To: Aaron Manley, Olympic Region Clean Air Agency
cc: Jennifer DeMay, Olympic Region Clean Air Agency; Michael Nolan and Christine Yanik, Weyerhaeuser NR Company
From: Nancy Liang and Matt Goldman, Trinity Consultants
Date: March 15, 2024
RE: Weyerhaeuser Raymond NOC Application Addendum (23NOC1614) – ORCAA Comments

On March 11, 2024 and March 12, 2024, Weyerhaeuser NR Company (Weyerhaeuser) received draft comments from Aaron Manley of the Olympic Region Clean Air Agency (ORCAA) regarding Notice of Construction (NOC) application #23NOC1614. The NOC application was submitted by Weyerhaeuser to authorize the installation of a direct-fired continuous dry kiln (CDK) at the Raymond facility (the "Facility"). This memo serves as an addendum to the NOC permit application and provides Weyerhaeuser's responses to ORCAA's comments.

Figure 5. Smelter Potroom Design

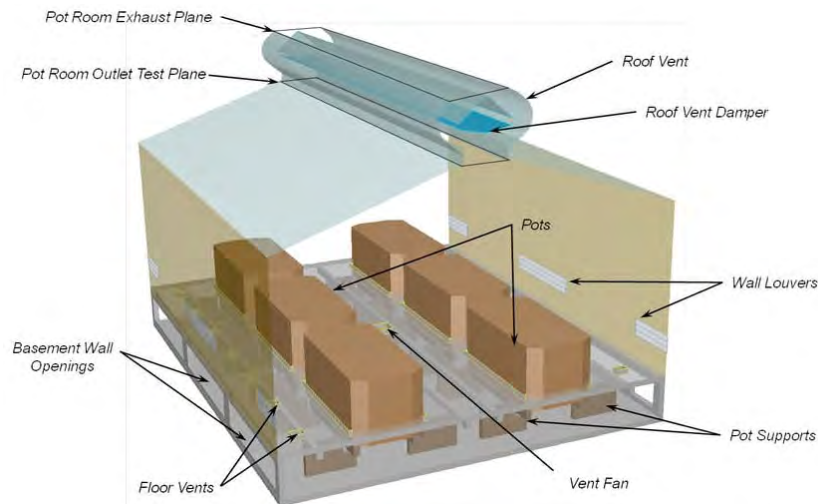
Jennifer DeMay of ORCAA has shared with Trinity Consultants (Trinity) that EPA and ORCAA would like Weyerhaeuser to consider the feasibility of extending the ends of the CDK and installing a “pressure balancing system” that is currently demonstrated at aluminum smelters, which uses a negative pressure to capture any remaining fugitive emissions. To Trinity’s knowledge, the aforementioned pressure balancing system is employed in smelter potrooms, which are long buildings that generate hot air exhaust, like a CDK. Potroom exhaust is primarily directed upward out of roof vents, but with the assistance of a pressure balancing system, most of the fugitive emissions can be captured and directed to an adjacent emission control system, also referred to as a Gas Treatment Center (GTC), which is displayed in Figure 4.

However, there are several key differences between the CDKs and smelter potrooms. As shown in Figures 5 and 6, a smelter potroom is a significantly larger structure that does not require open doors for product to continuously travel in and out through. Also, potrooms are typically designed with roof vents along the length of the structure, where the majority of the exhaust is directed to, as well as open louvers on the building's walls. Therefore, the emission profile differs from that of a CDK. Even with a pressure balancing system, there still remains an amount of uncaptured fugitive emissions when using the pressure balancing system.
